2300  
E. LIVINGSTON  
AVENUE

THE COMMUNITY  
BUILDERS

RDL  
ARCHITECTS

**2300 E. LIVINGSTON | PREVIOUS DESIGN - FEBRUARY 13, 2025 ABR**

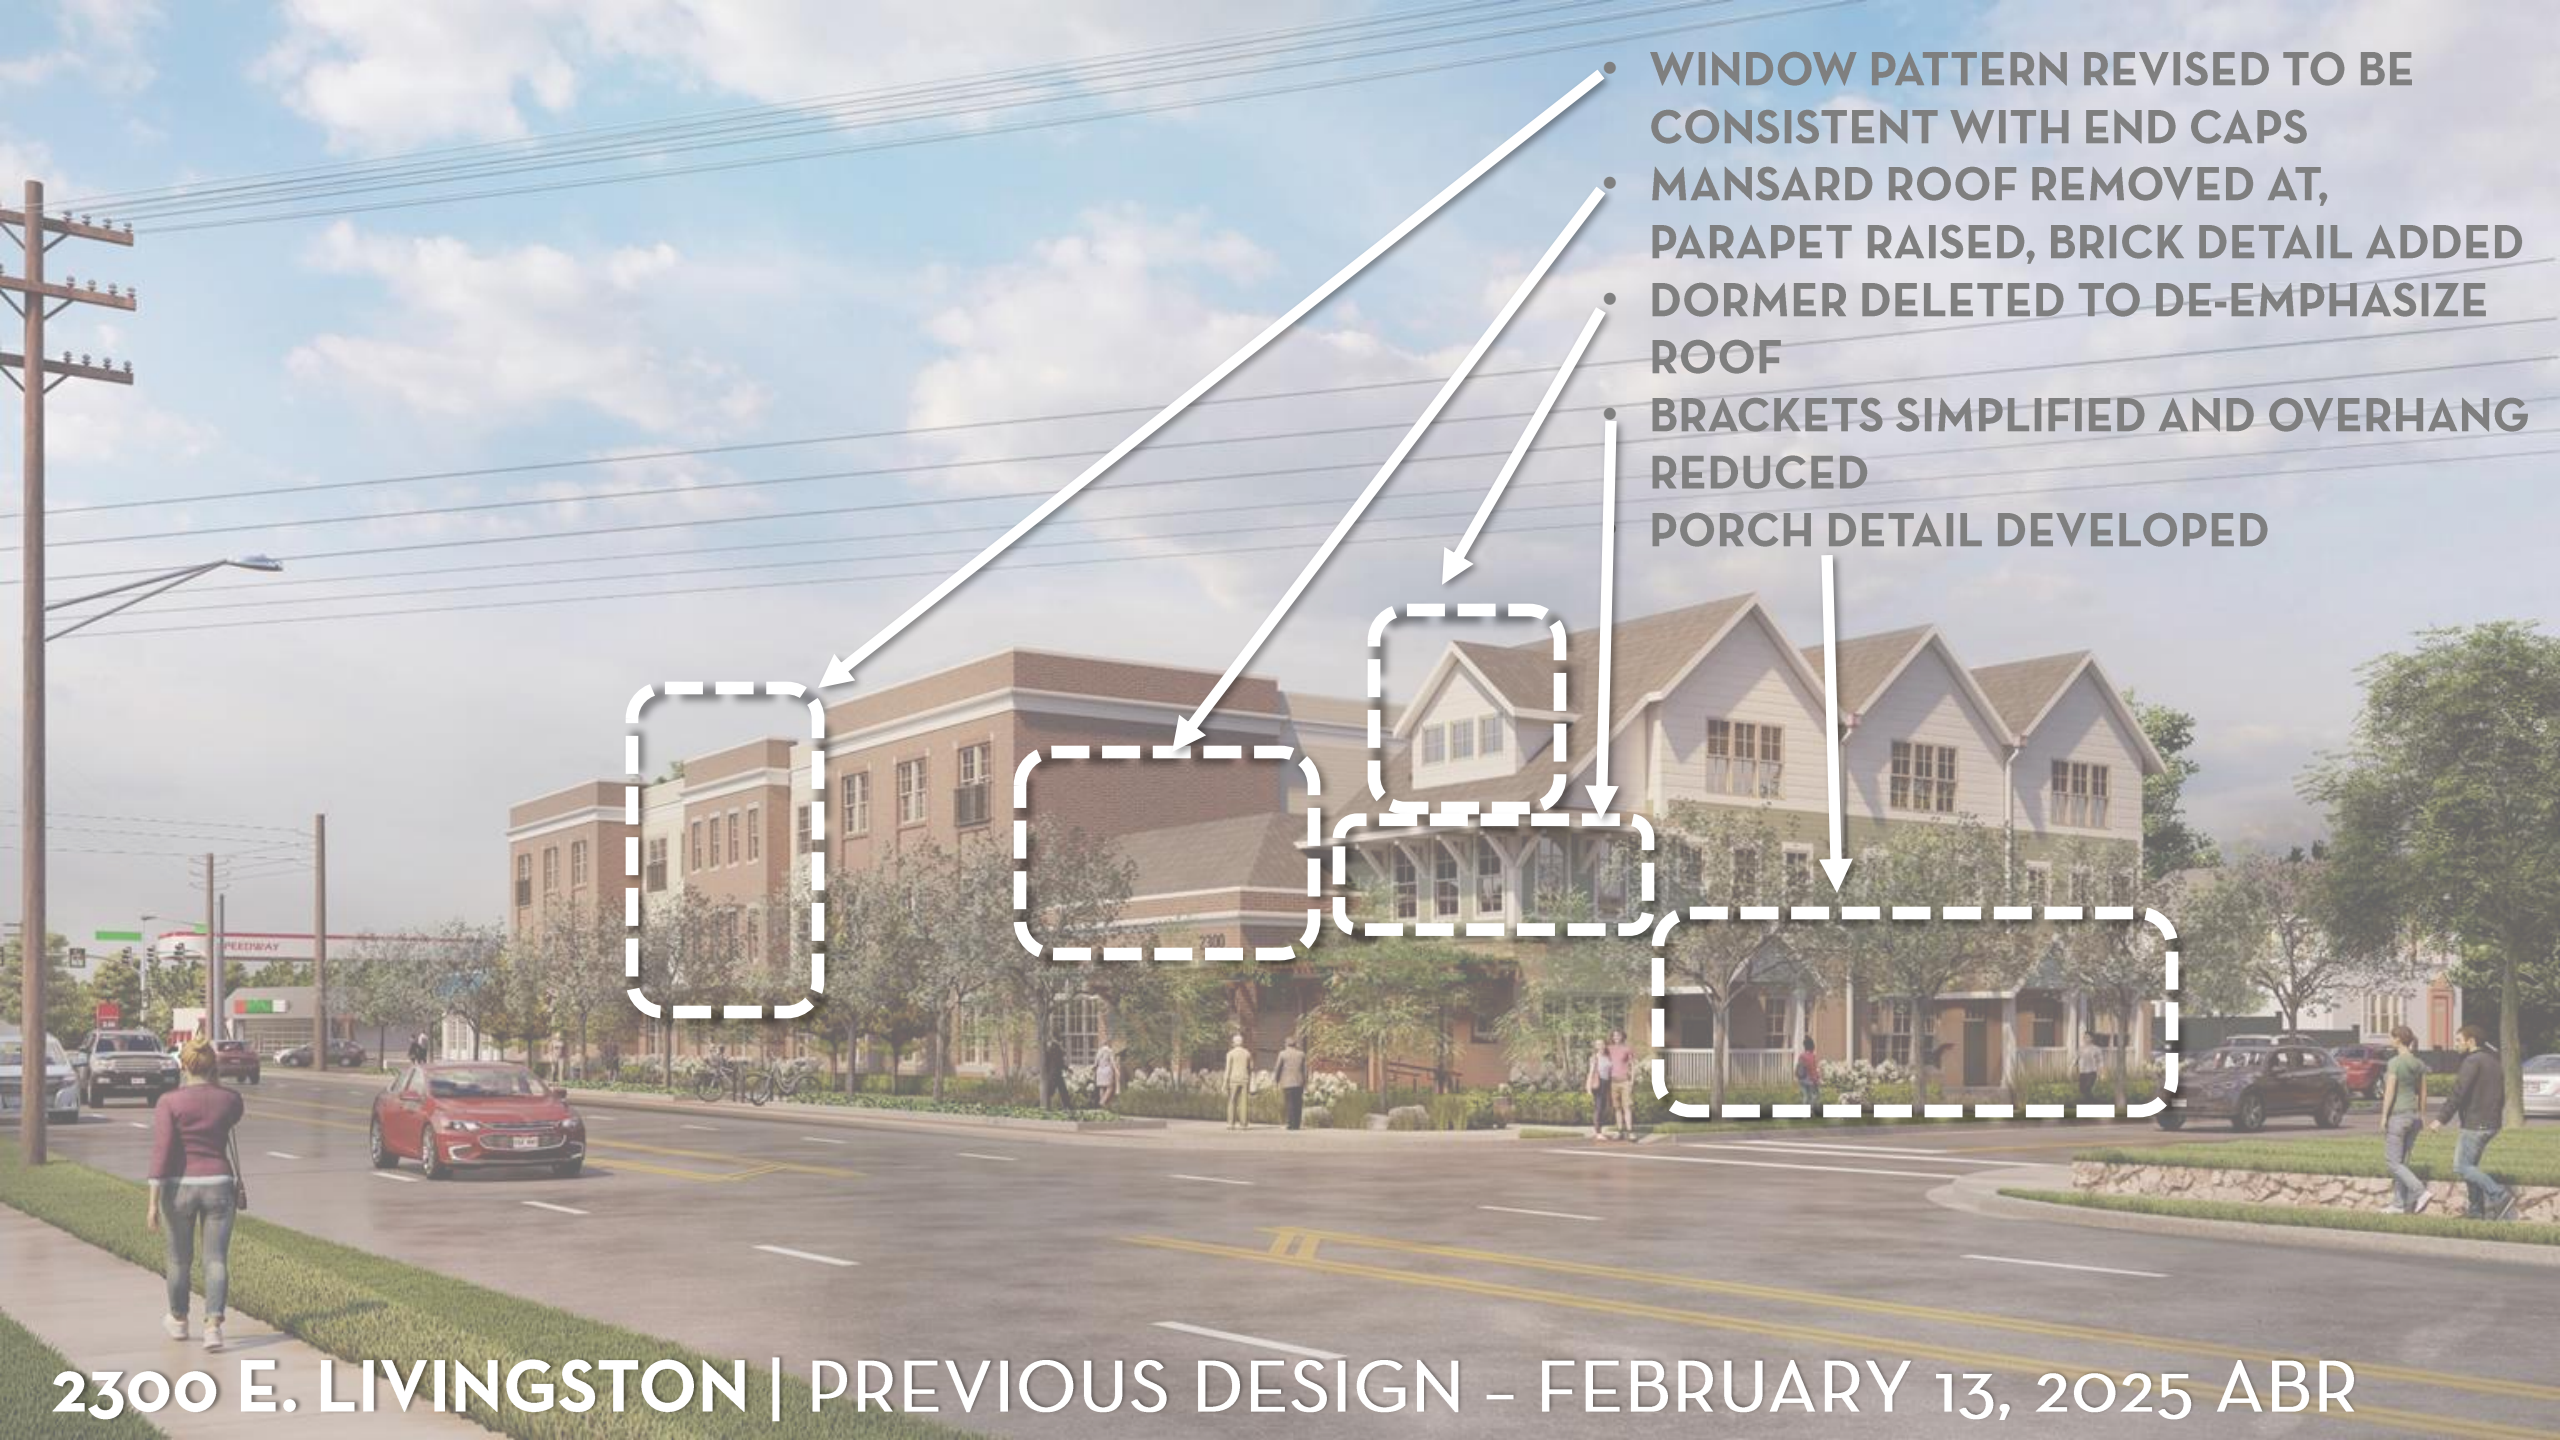
- WINDOW PATTERN REVISED TO BE CONSISTENT WITH END CAPS
- MANSARD ROOF REMOVED AT, PARAPET RAISED, BRICK DETAIL ADDED
- DORMER DELETED TO DE-EMPHASIZE ROOF
- BRACKETS SIMPLIFIED AND OVERHANG REDUCED
- PORCH DETAIL DEVELOPED
